CITY of NOVI CITY COUNCIL June 2, 2025

SUBJECT: Consideration of a Special Land Use and Preliminary Site Plan approval for Dick's

House of Sport

Dick's Sporting Goods JSP24-31 March 14, 2025

DRAWING NO.

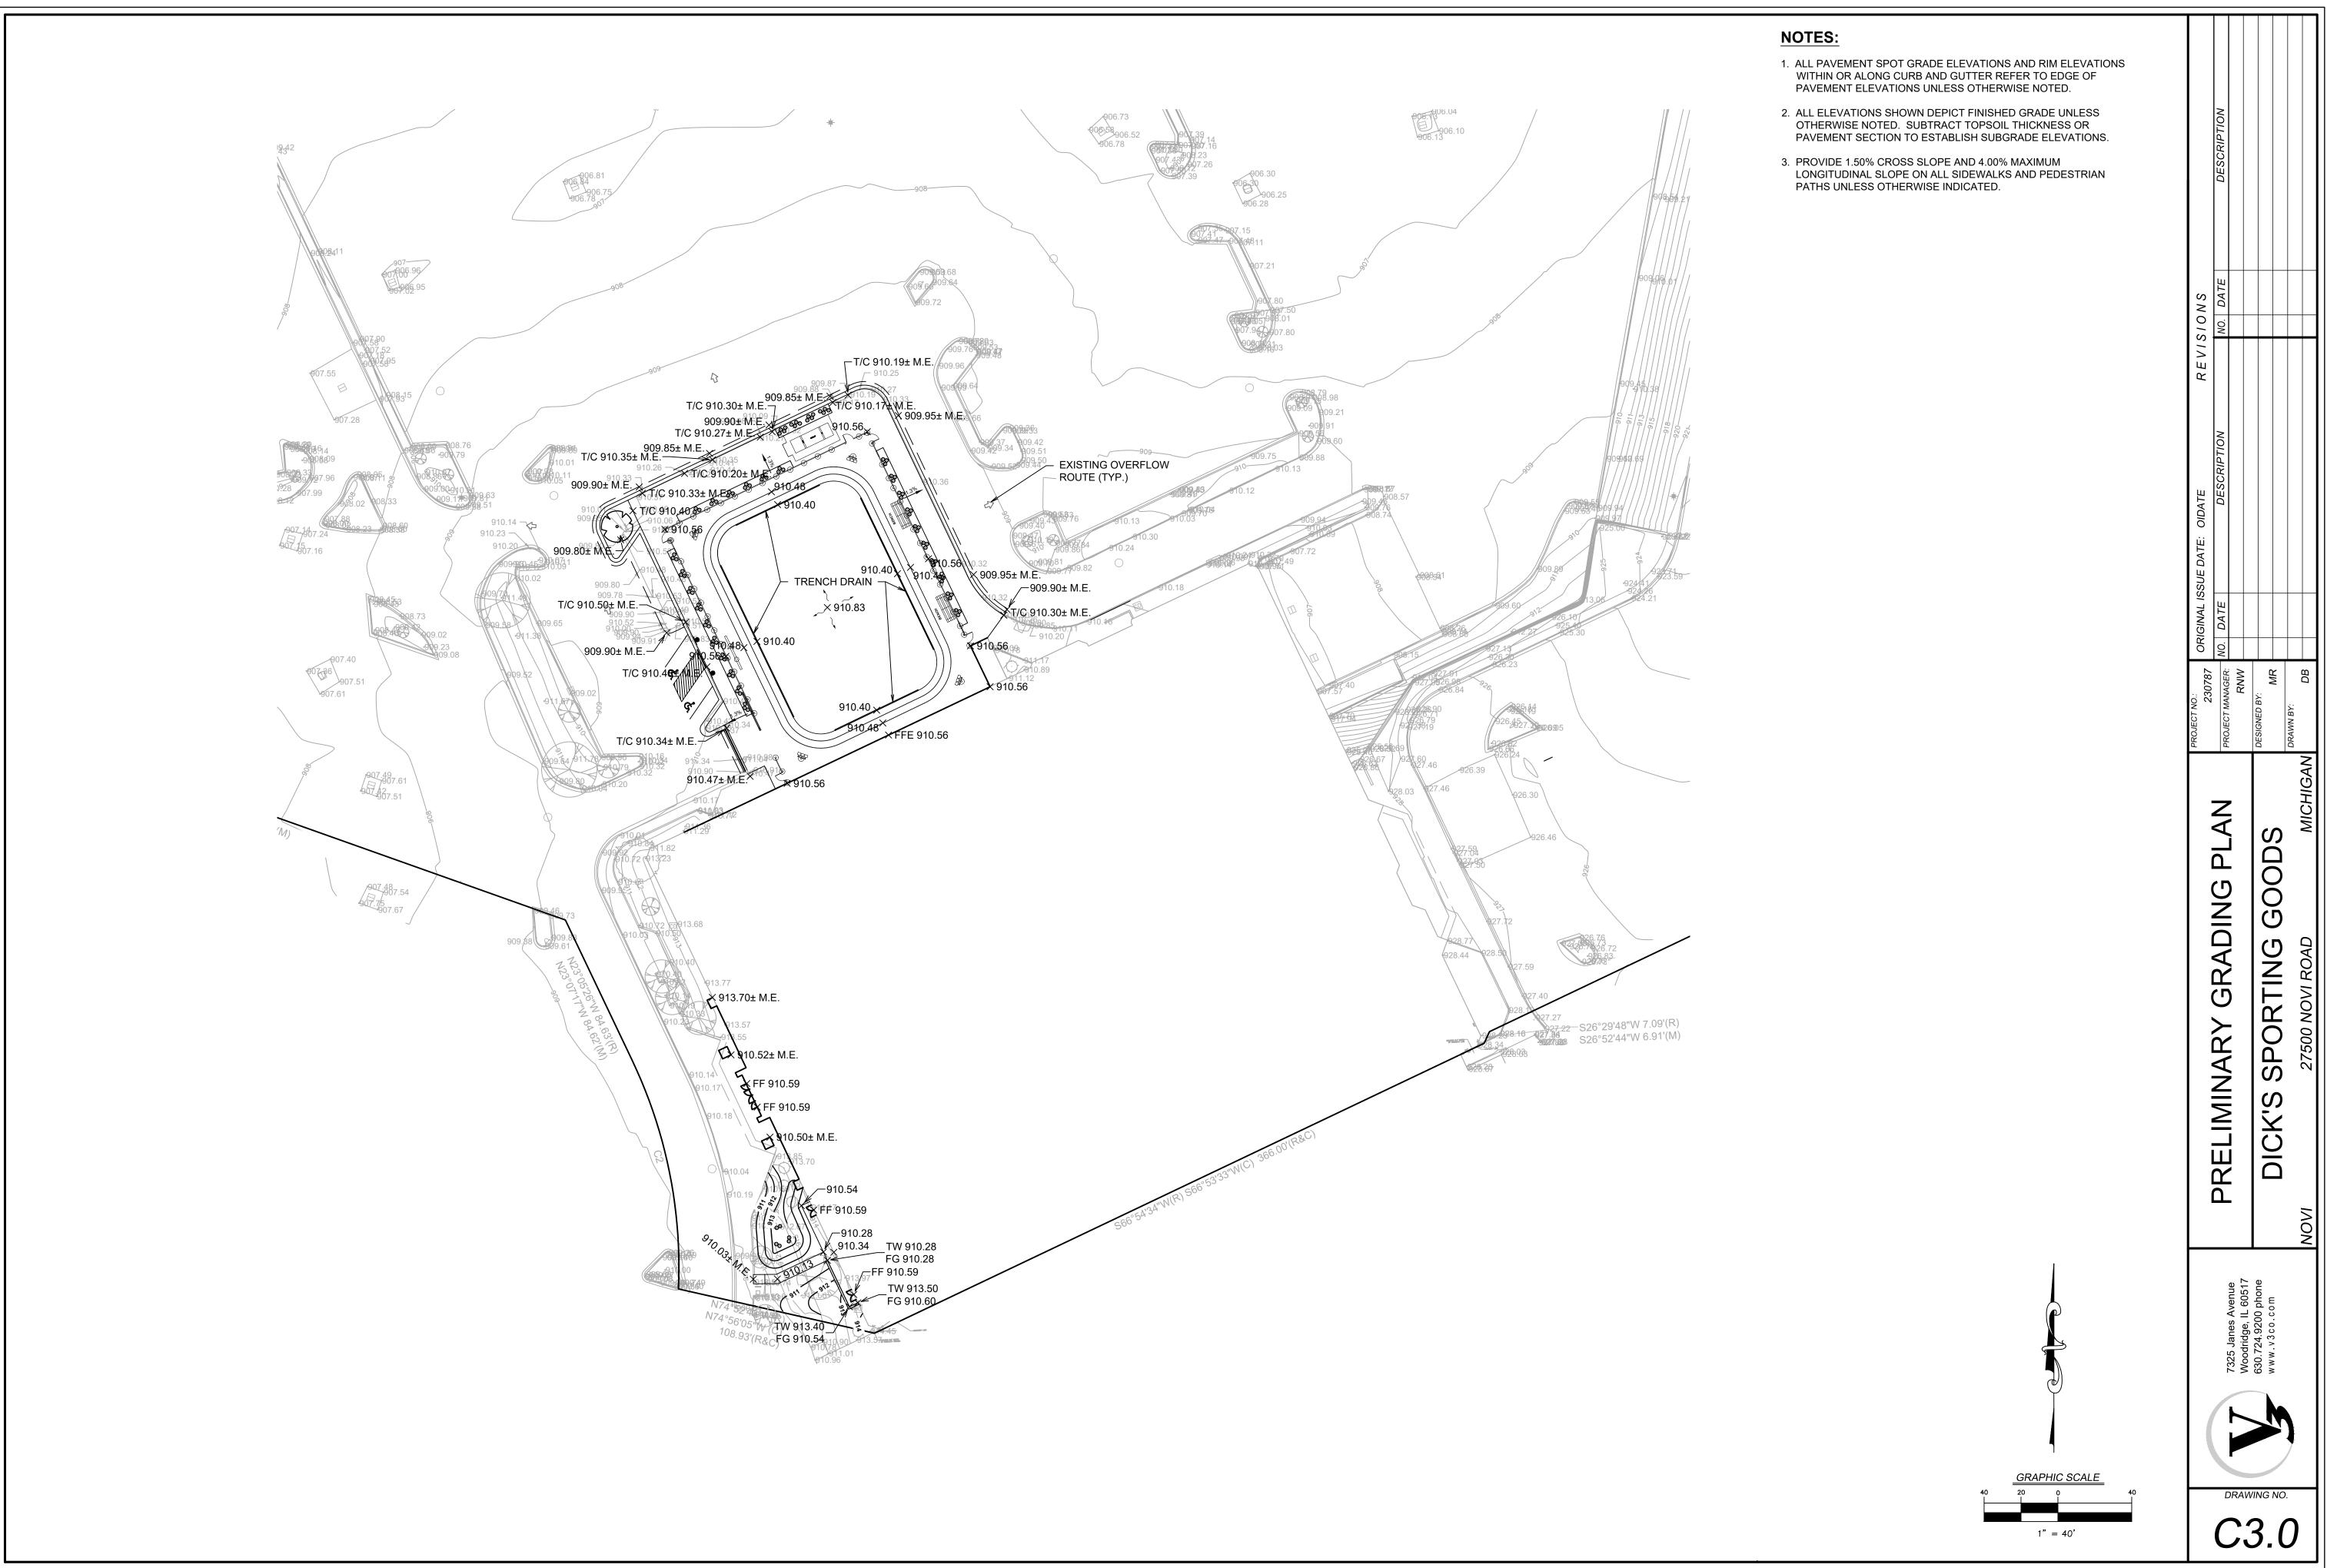
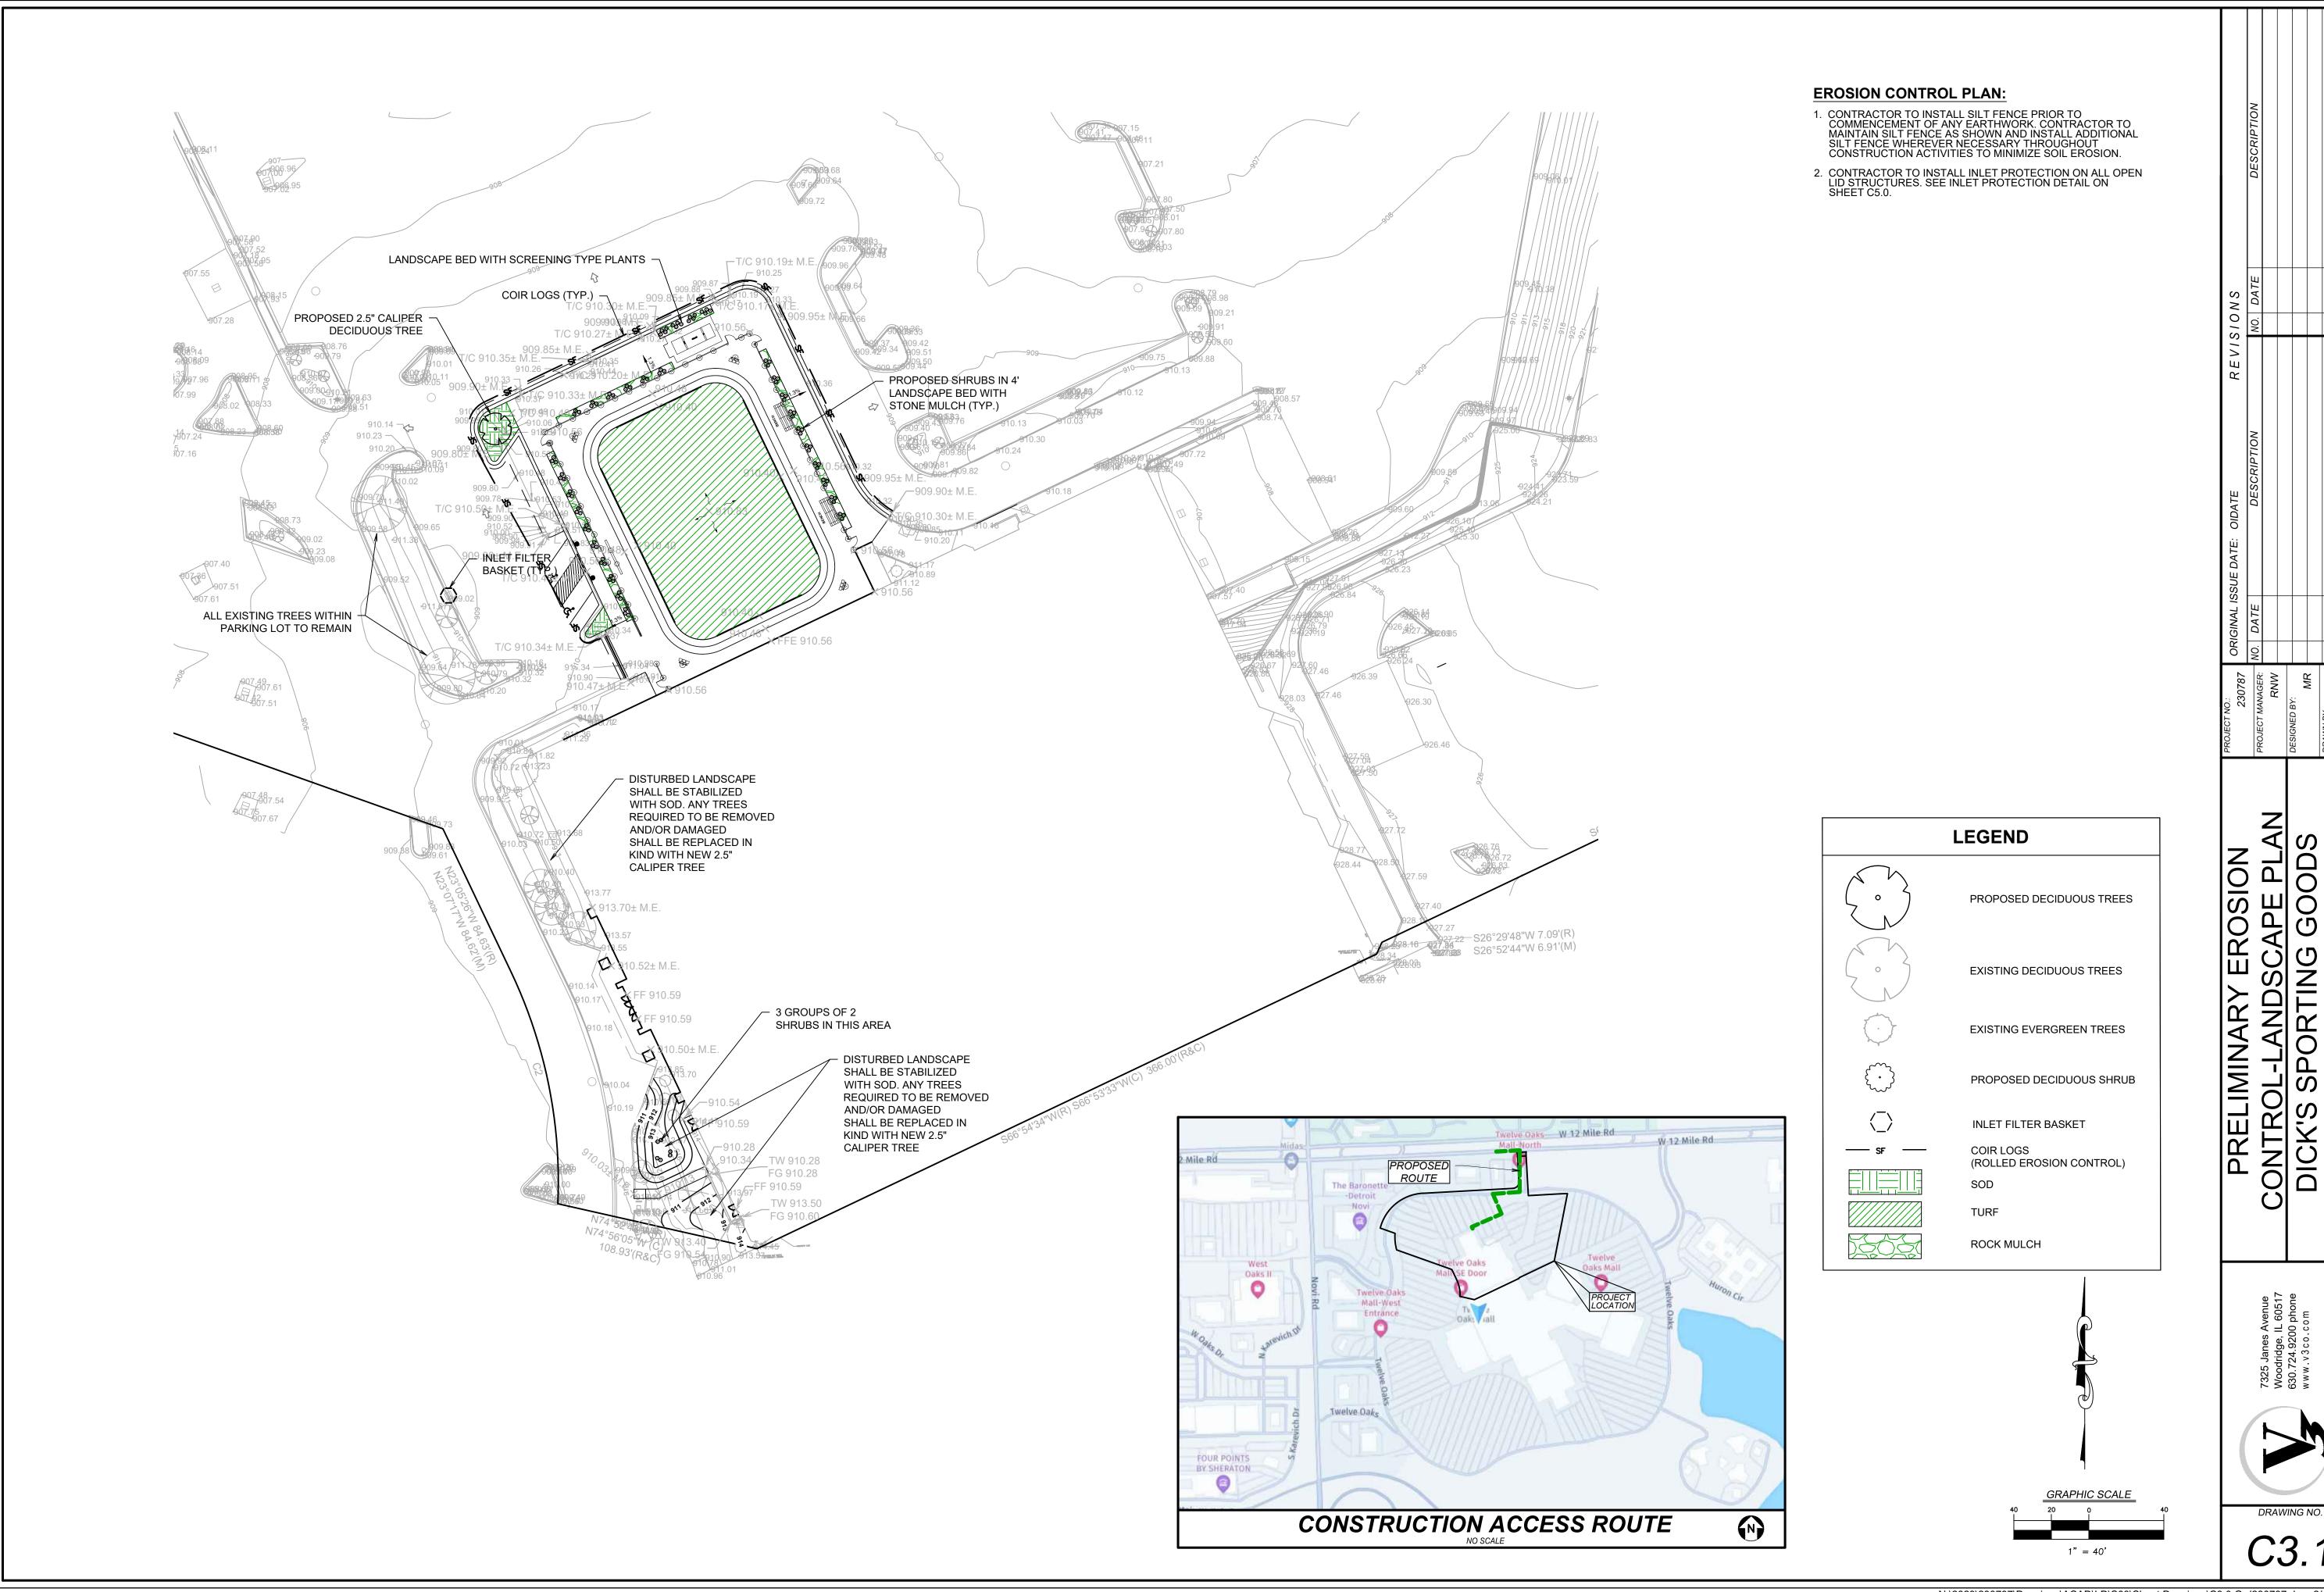
Comment 15: Sheet C4.0 indicates 18' light poles, lighting specifications and response letter indicate
